World Forum for Harmonization of Vehicle Regulations**Working Party on Noise and Tyres****Seventy-third session**

Tyres: UN Regulation No. 30 (Tyres for passenger cars and their trailers)**Proposal for a new Supplement to the 02 series of amendments to UN Regulation No. 30****Submitted by the experts from the European Tyre and Rim Technical Organisation***

Paragraph 3.1.14., symbol, replace to read:

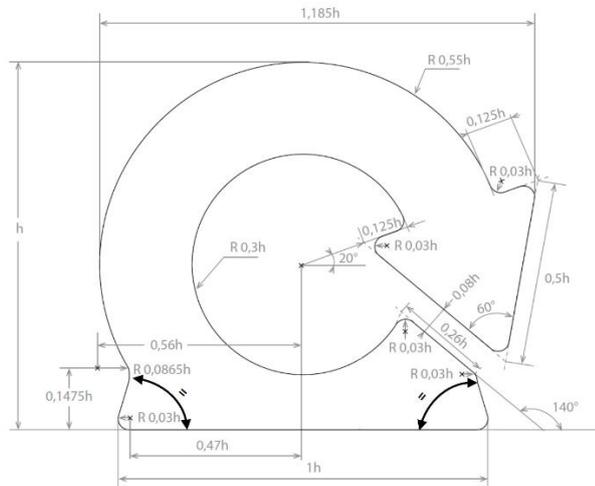
1. This document presents an amendment to the extended mobility tyre (EMT) symbol following the detection of dimensional inconsistencies within the International Organization for Standardization Working Group (ISO) TC31/SC3/WG19, where the dimension "0,33h" was judged wrong and constituting an unnecessary over constraint. ISO experts agreed to correct the standard ISO 16992:2018 EMT symbol by removing such dimension and introducing the information that the two angles at the base are the same. This amendment is important to allow symbol implementation and to ensure no deviation from the requirement in reproducing it.
